| Product hierarchy no. * | | | | Part no. | SBU | Type / Description | Customer part no. |
|-------------------------|-----|-----|------------|----------------|--------------------------------|--------------------|-------------------|
| 02 | 006 | 016 | 0000001606 | See list below | Power Entry Module with Filter | 5123 | |

Implementation of V-Lock cord retaining feature as standard.

| Product Change Notification | | | | | PCN 5123 with V-Lock | | |

| Old product appearance | New product appearance |
|--|---|
| <p>Protection class I</p>  | <p>Protection class I</p>  |

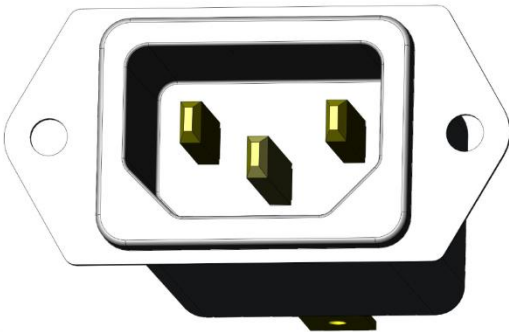
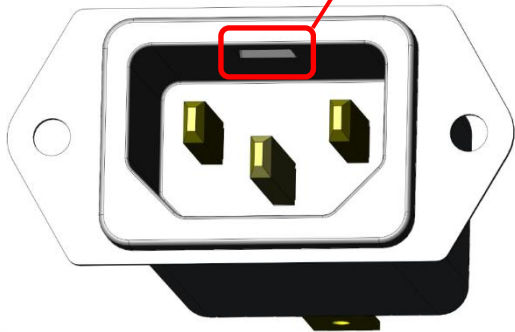
V-Lock feature integrated as standard (not an option anymore)

| Form | Yes | Socket has notch for V-Lock cord |
